# HISTORIC AND DESIGN REVIEW COMMISSION

August 04, 2021

**HDRC CASE NO:** 2021-350  
**ADDRESS:** 407 E EVERGREEN  
**LEGAL DESCRIPTION:** NCB 396 BLK 29 LOT 8  
**ZONING:** MF-33,H  
**CITY COUNCIL DIST.:** 1  
**DISTRICT:** Tobin Hill Historic District  
**APPLICANT:** MARK SALVADOR/FISHER HECK ARCHITECTS  
**OWNER:** ROSEN RANDALL A & CYNTHIA E  
**TYPE OF WORK:** Construction of two, 1-story rear accessory structures, exterior modifications  
**APPLICATION RECEIVED:** July 12, 2021  
**60-DAY REVIEW:** Not applicable due to City Council Emergency Orders  
**CASE MANAGER:** Stephanie Phillips  
**REQUEST:**

3 GARAGE NORTH ELEVATION  
3/8" = 1'-0"

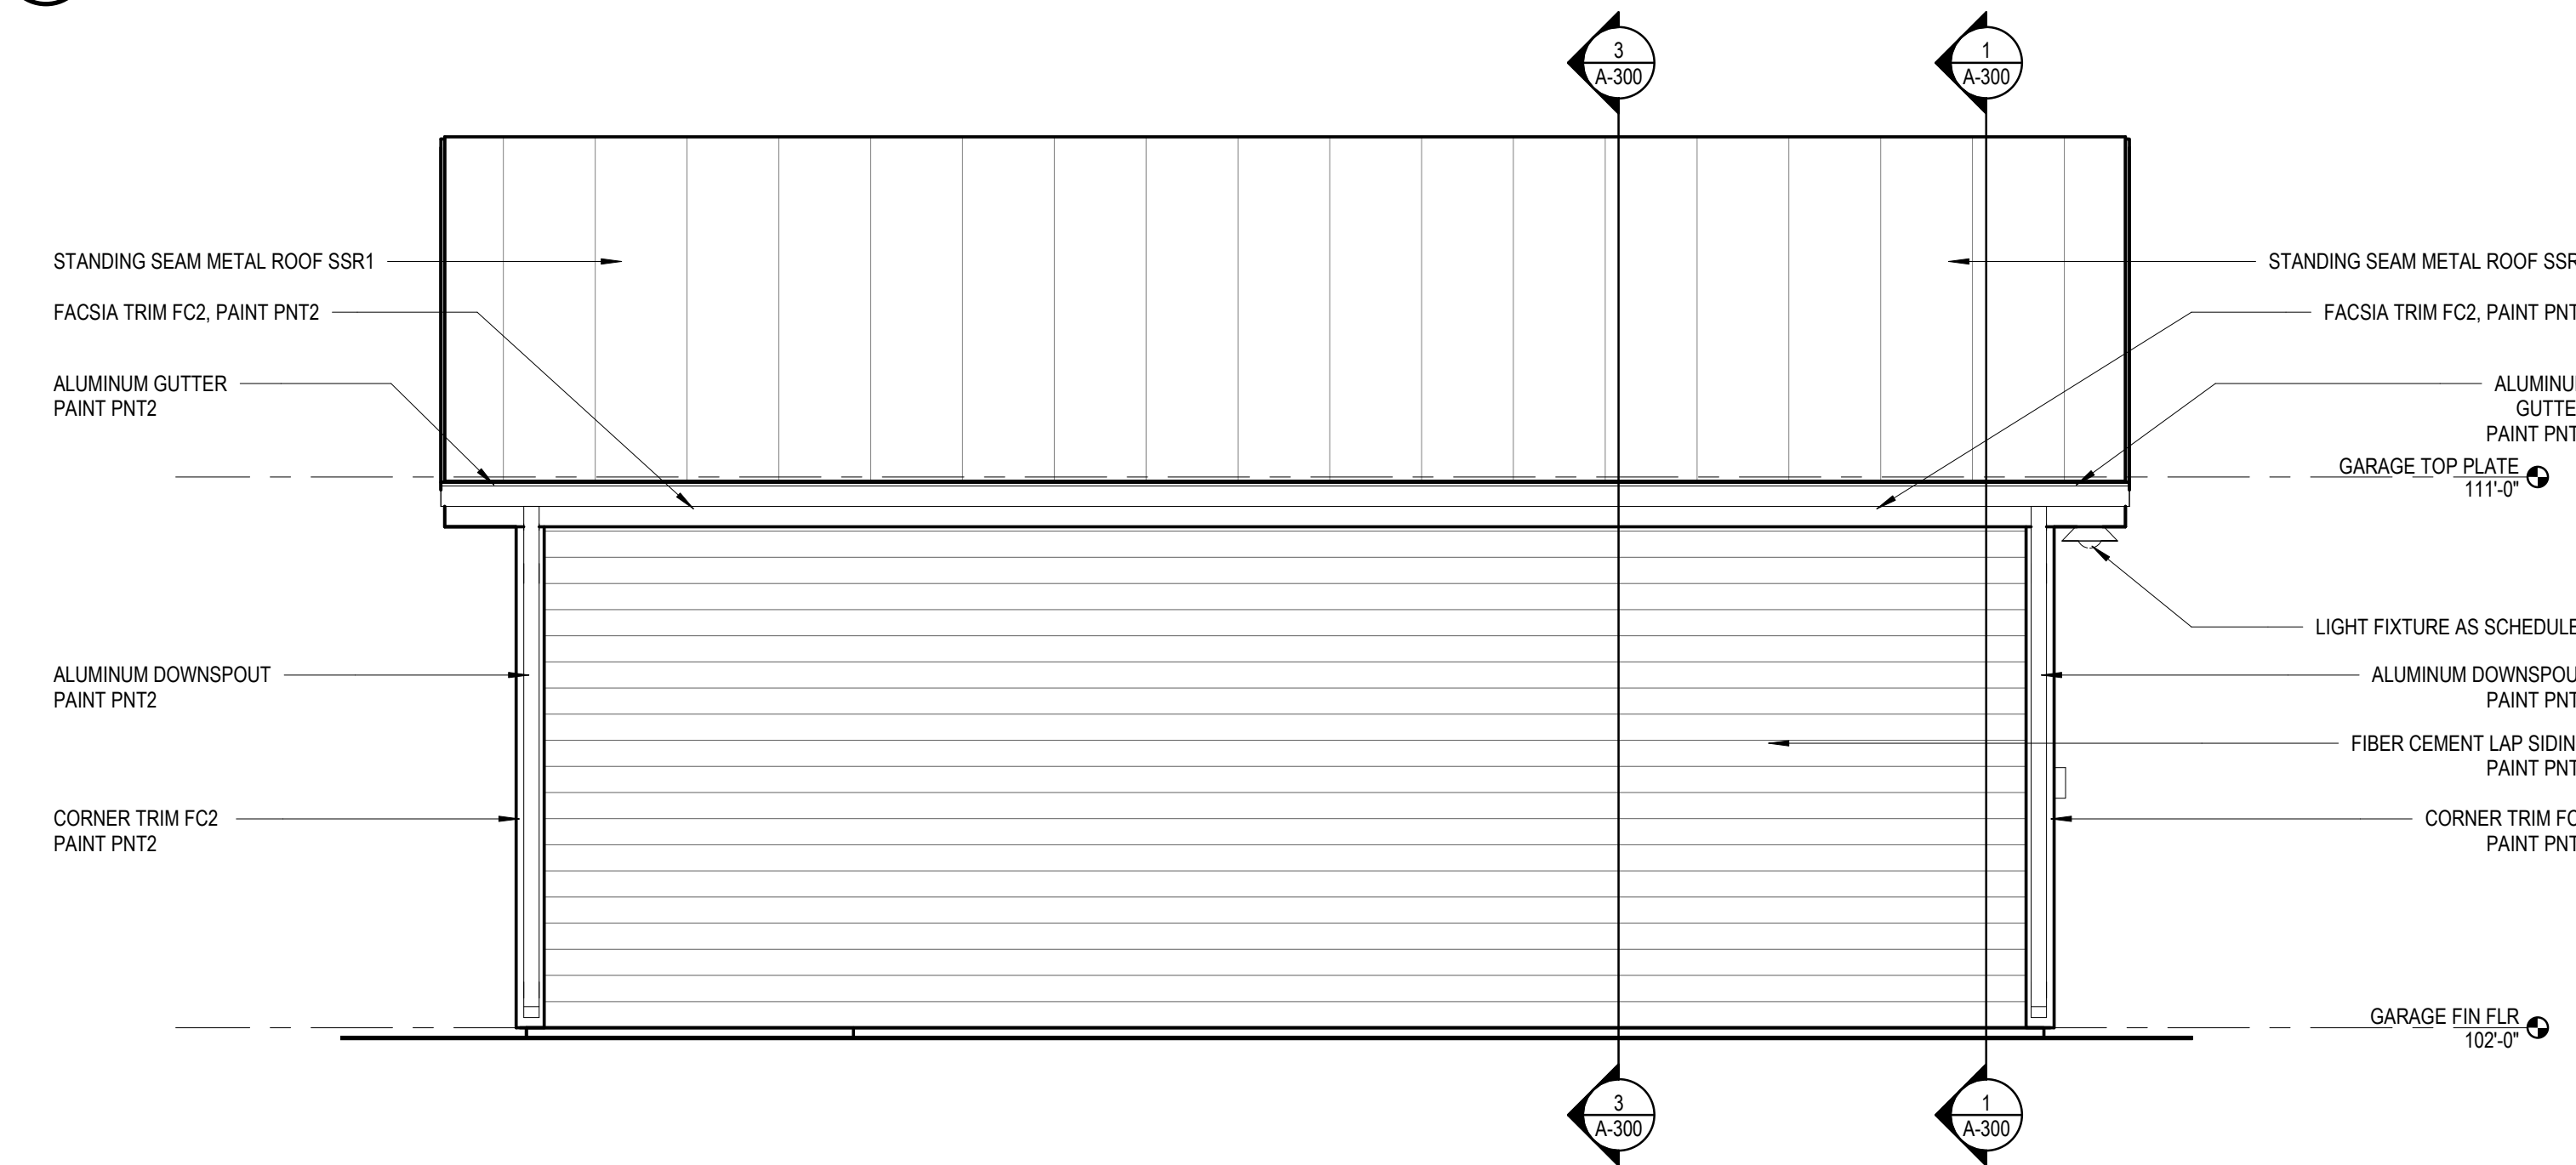
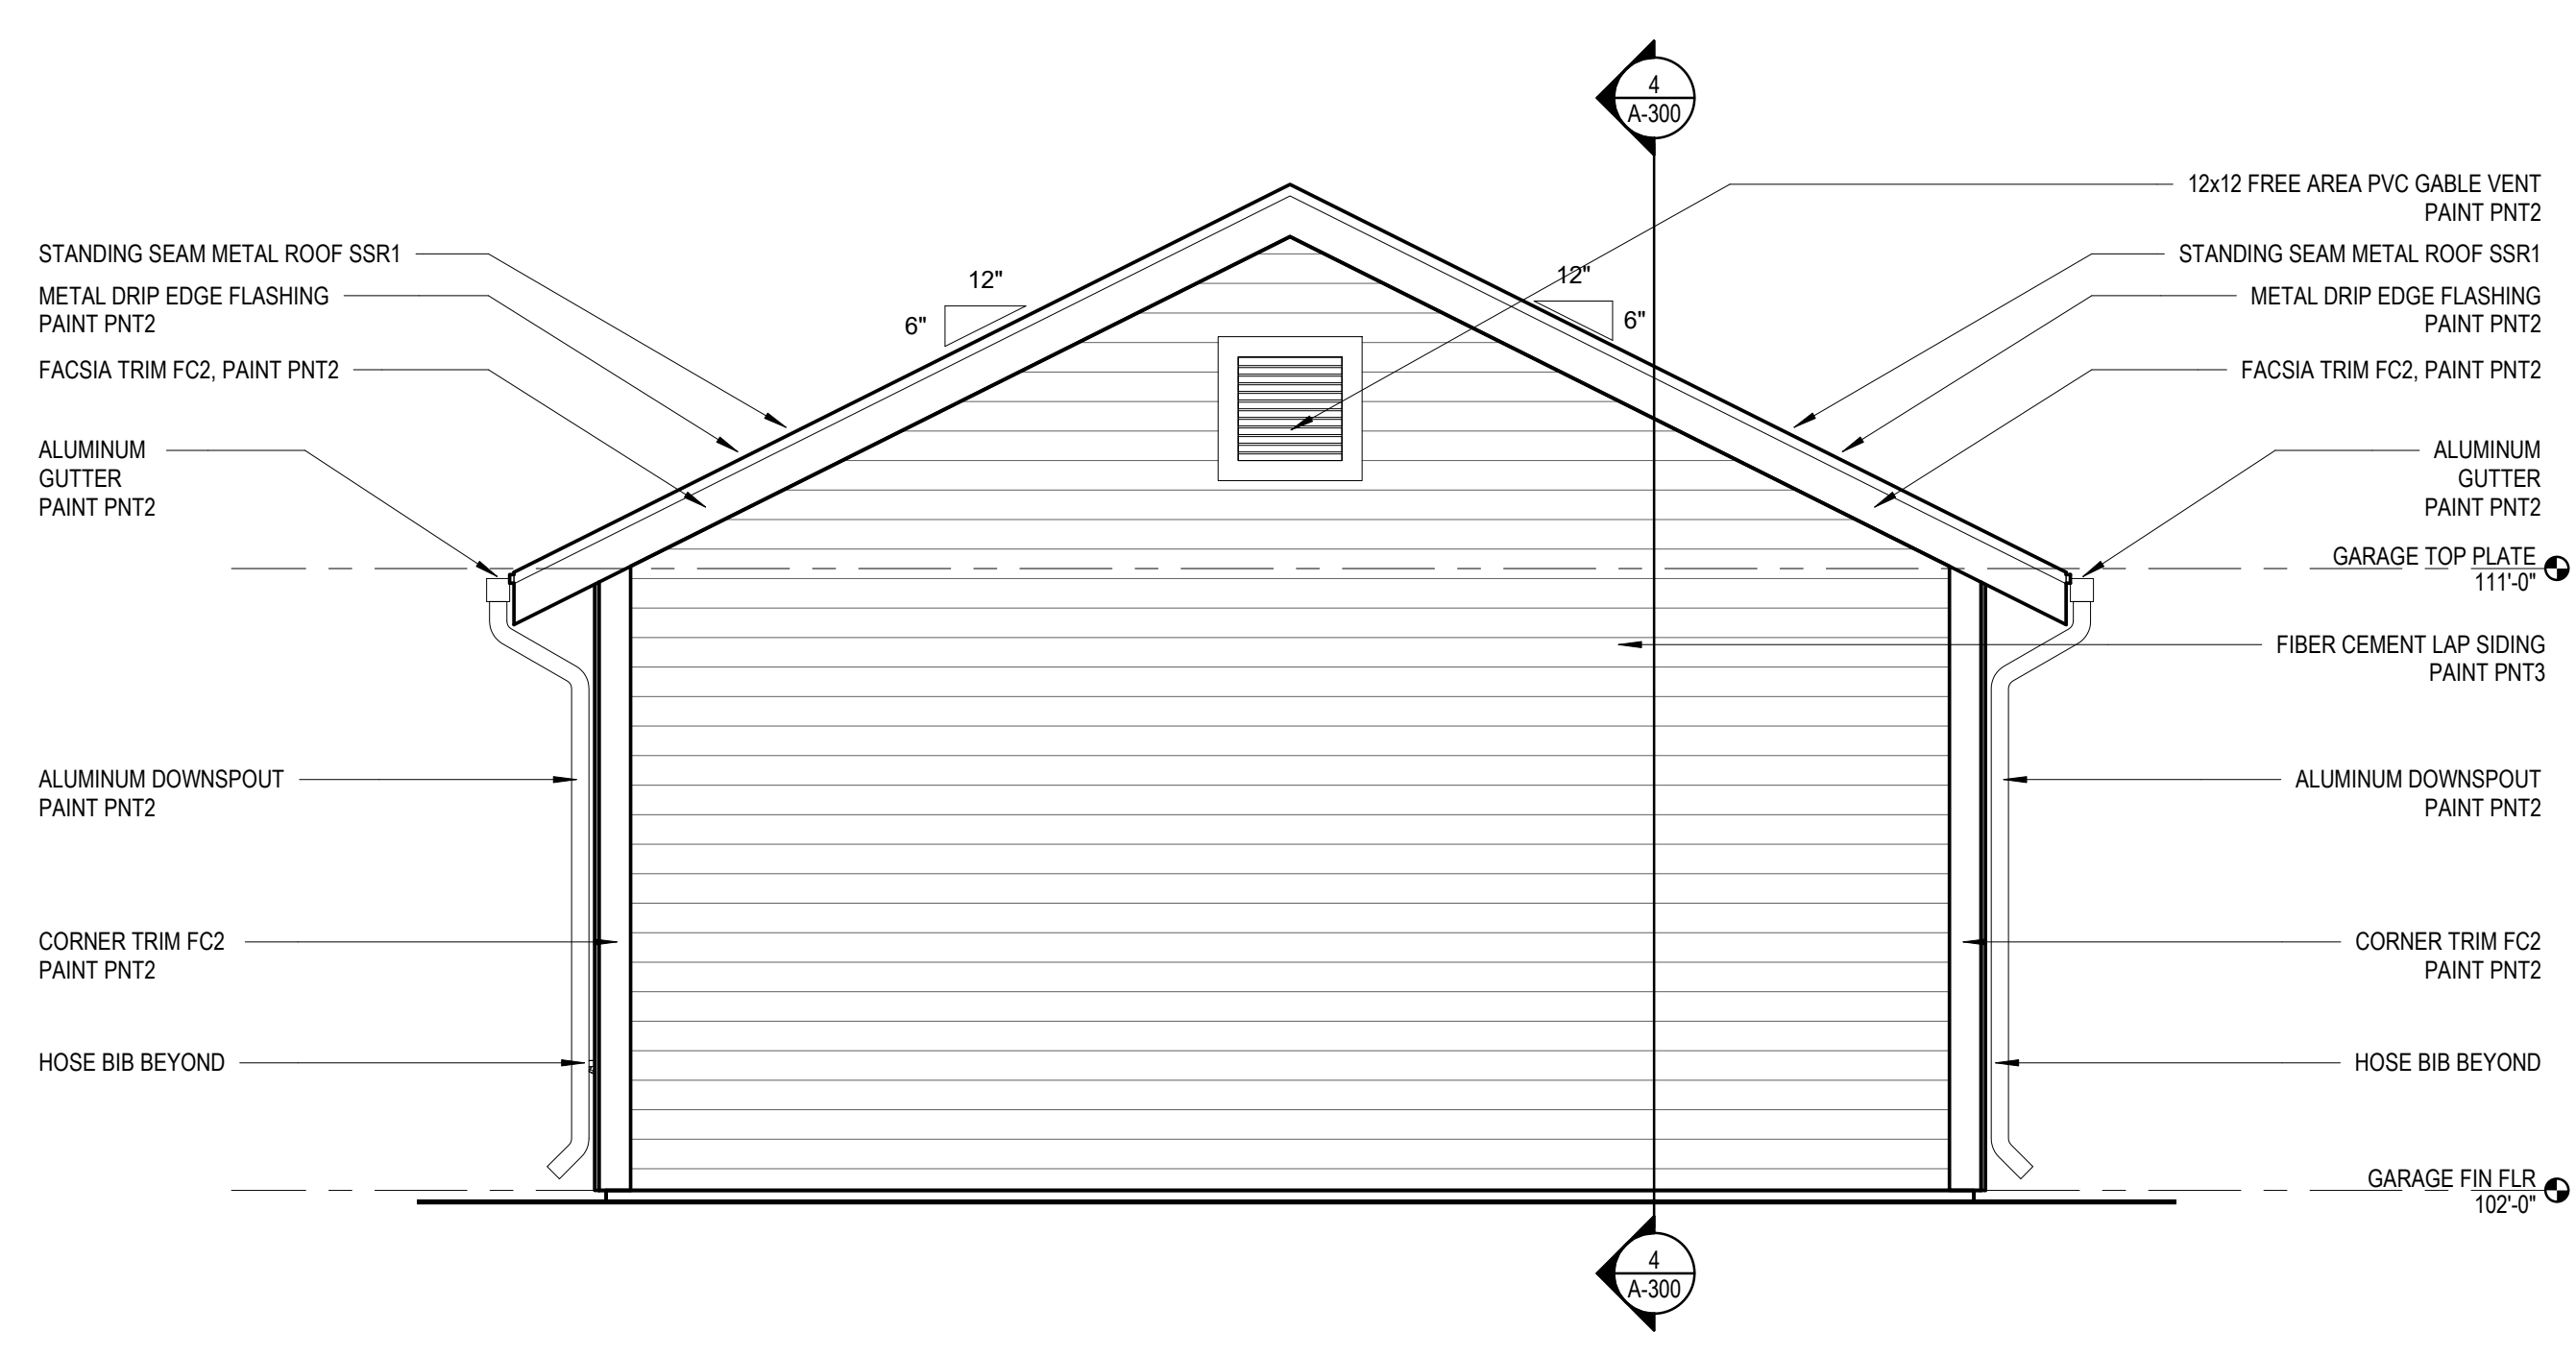
- e. **FENESTRATION** – According to the Historic Design Guidelines, openings in new construction should use traditional dimensions and profiles found on the primary structure or within the historic district. Based on the submitted elevations, the applicant has proposed one over one windows and door configurations that are consistent with historic patterns. The applicant has also proposed a double-width garage door. Staff generally finds the window patterns and pedestrian doors appropriate with the stipulations listed in the recommendation, but finds that the applicant should install two single-bay garage doors in lieu of the proposed double-width garage door to be more consistent with the Guidelines.

- i. That the applicant installs two single bay garage doors in lieu of the proposed double width overhead door as noted in finding g.
- ii. That the applicant installs a fully wood or aluminum clad wood window that meet staff's standard window stipulations and submits updated specifications to staff for review and approval. The windows should feature an inset of two (2) inches within facades and should feature profiles that are found historically within the immediate vicinity. Meeting rails must be no taller than 1.25" and stiles no wider than 2.25". White manufacturer's color is not allowed, and color selection must be presented to staff. There should be a minimum of two inches in depth between the front face of the window trim and the front face of the top window sash. This must be accomplished by recessing the window sufficiently within the opening or with the installation of additional window trim to add thickness. Window trim must feature traditional dimensions and architecturally appropriate sill detail. Window track components must be painted to match the window trim or concealed by a wood window screen set within the opening. All paired windows should feature a true ganged condition as noted in finding e.
